UNITED STATES PATENT AND TRADEMARK OFFICE

APPLICATION NO.	FILING DATE	FIRST NAMED INVENTOR	ATTORNEY DOCKET NO.	CONFIRMATION NO.
10/078,182	02/19/2002	Charles Lange	P01,0383 (H17-25172)	5447

Office Action Summary	Application No.	Applicant(s)	
	10/078,182	LANGE, CHARLES	
	Examiner	Art Unit	
	Samuel A. Turner	2877

DETAILED ACTION

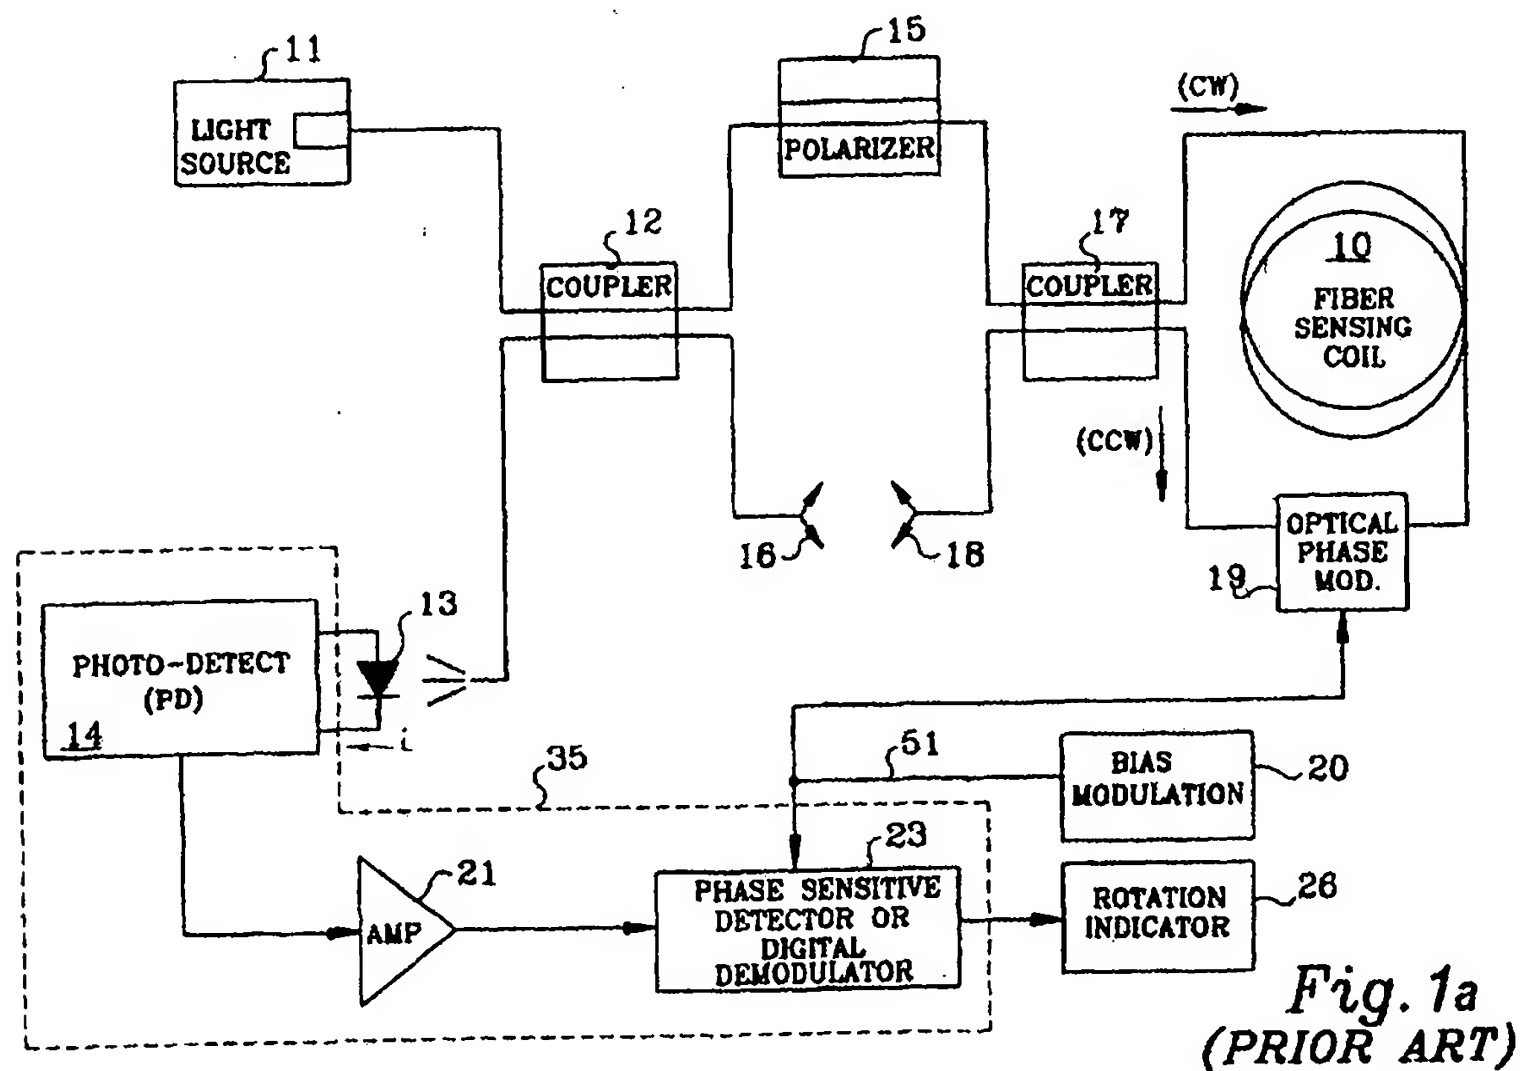
Claims 1-5, 8-10, 13, and 14 are rejected under 35 U.S.C. § 103(a) as being unpatentable over applicant's prior art figure 1a in view of Udd et al(Optical Fiber Rotation Sensing).

The prior art of applicant's figure 1a teaches a well known open loop Sagnac type fiber optic gyroscope comprising a broadband source(11), first coupler(12), polarizer(15), second coupler(17), sensing coil(10), phase modulator(19), and a phase sensitive detector(35). A bias modulator driver(20) is included to drive the phase modulator at the proper or fundamental frequency $f=1/2\tau$ to provide a $\pi/2$ bias to the counter-rotating beams. The modulator is usually driven using either a

sinusoidal or square waveform. The phase sensitive detector(35) includes a photodetector(13,14), synchronous demodulator(23) which provides the gyro output. The synchronous demodulator demodulates the gyro output signal using the bias modulation drive signal(51). Not specifically taught is a sawtooth waveform used in driving the bias modulator.

Fig. 3.5. A gyro sensing loop with a phase modulator (PM) located at the center of the loop.

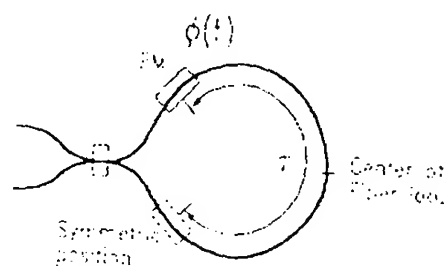
phase modulator at the proper frequency $f=1/2\tau$ to provide a $\pi/2$ bias to the counter-rotating beams. Also note figure 3.5 which includes a symmetrical coupler.

With regard to claims 7 and 12; it would have been obvious to one of ordinary skill in the art to use a plurality of modulators instead of combining the ramp or serrodyne waveform with the bias waveform on a single phase modulator thus the different signals can be feed to separate symmetric modulators as found in figure 3.5 of Udd.

Fig. 3.6. Differential phase modulation waveforms $\Delta\phi(t)$ for several periodic phase modulation waveforms $\phi(t)$ and for two values of $\omega\tau$.

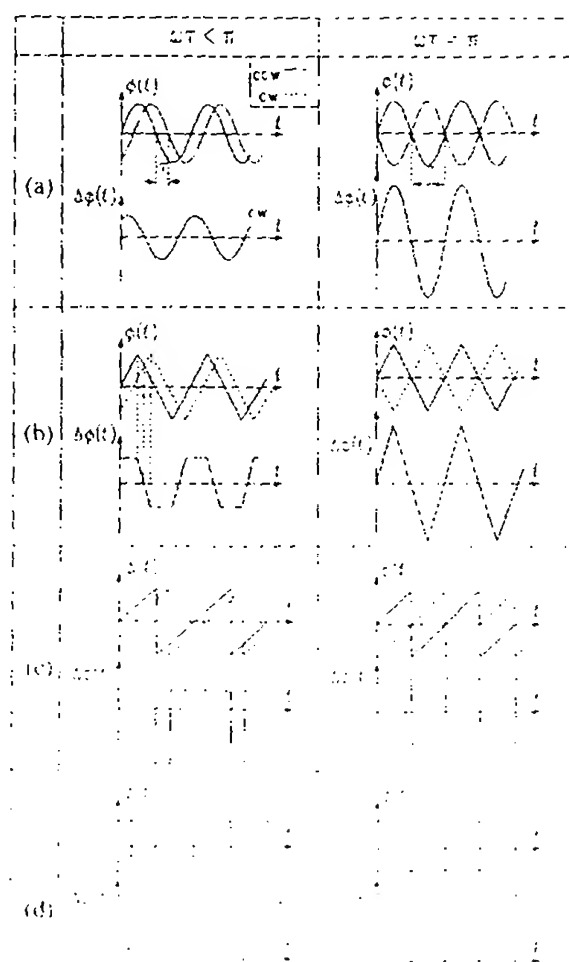
In the Udd text, Chapter 3 entitled "Signal Processing Techniques" written by B.Y. Kim, specific attention is directed to figure 3.6 which shows several prior art phase modulator drive signals. Included are sinusoidal(a), square(d), triangular(b), and sawtooth(c). All of these different waveforms are used to drive a fiber gyro

It would have been obvious to one of ordinary skill in the art at the time the invention was made to drive the prior art fiber gyroscope shown in applicant's figure 1a by any of the known phase modulation waveforms including a sawtooth waveform.

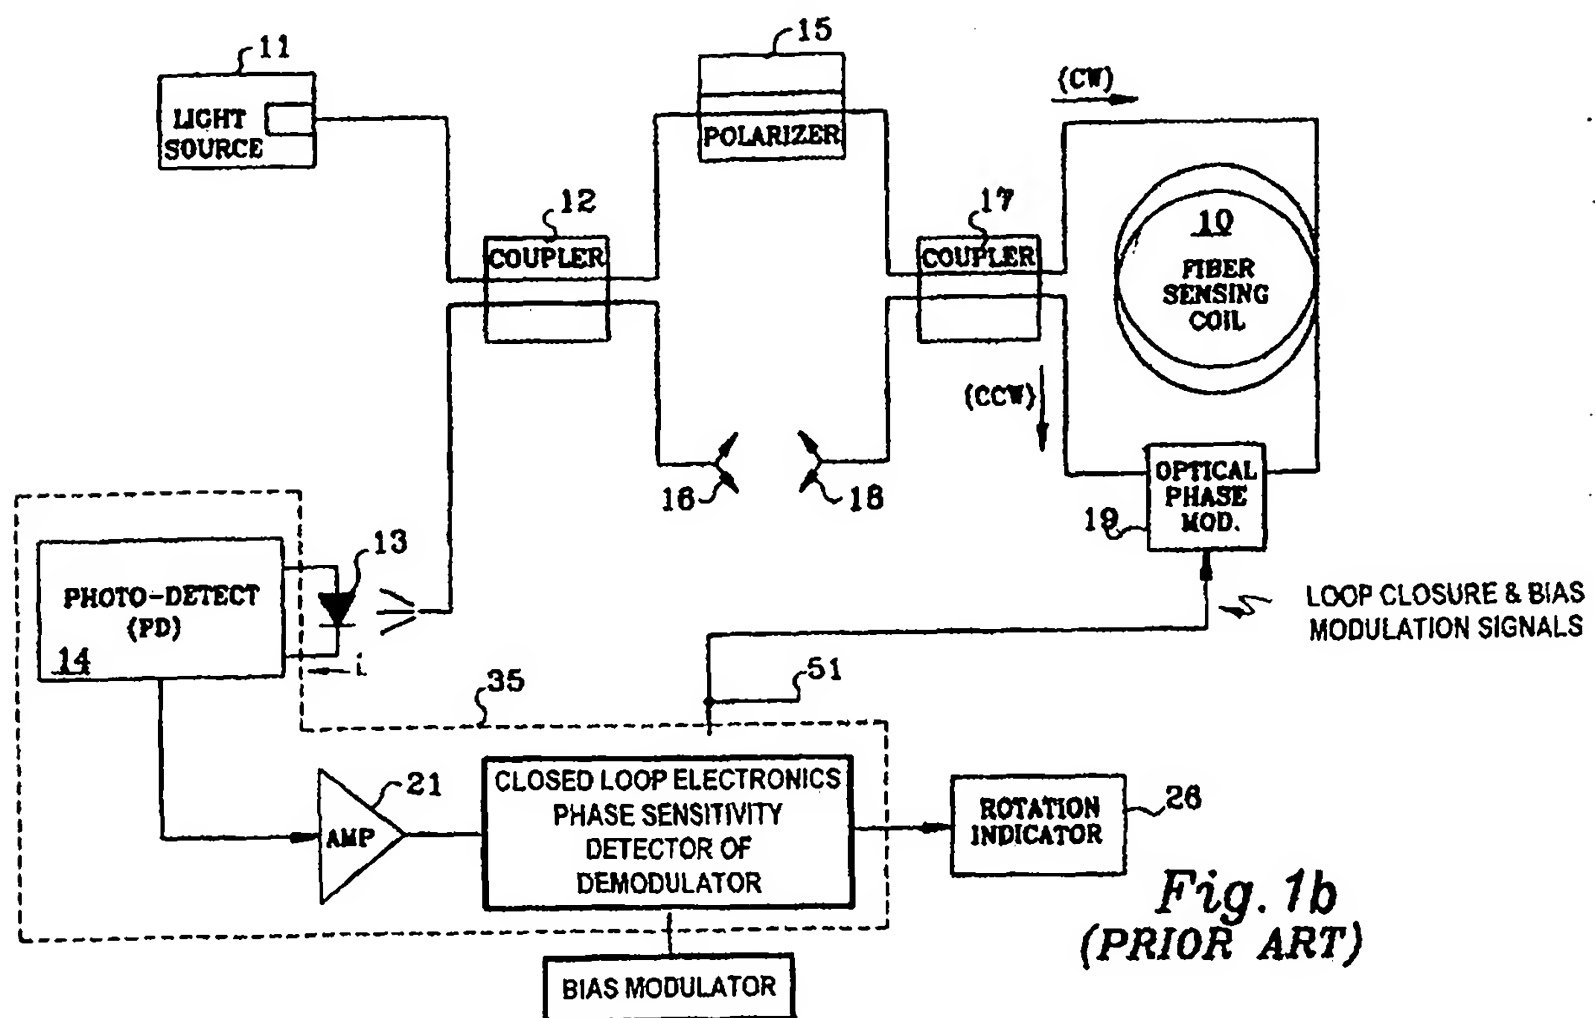
Claims 6, 7, 11, and 12 are rejected under 35 U.S.C. § 103(a) as being unpatentable over applicant's prior art figure 1a and Udd et al(Optical Fiber Rotation Sensing) as applied to claims 1-5, 8-10, 13, and 14 above, and further in view of applicant's prior art figure 1b.

Applicant's prior art figure 1b further includes a closed loop fiber optic gyroscope configuration. In the closed loop configuration the output of the

synchronous demodulator(23) is used to drive a phase ramp or serrodyne waveform which is added to the bias modulator waveform. By closing the loop the gyro is drive by the ramp or serrodyne waveform to a phase null point.

It would have been obvious to one of ordinary skill in the art at the time the invention was made to include a closed loop to drive the gyro back to the null point of maximum sensitivity.
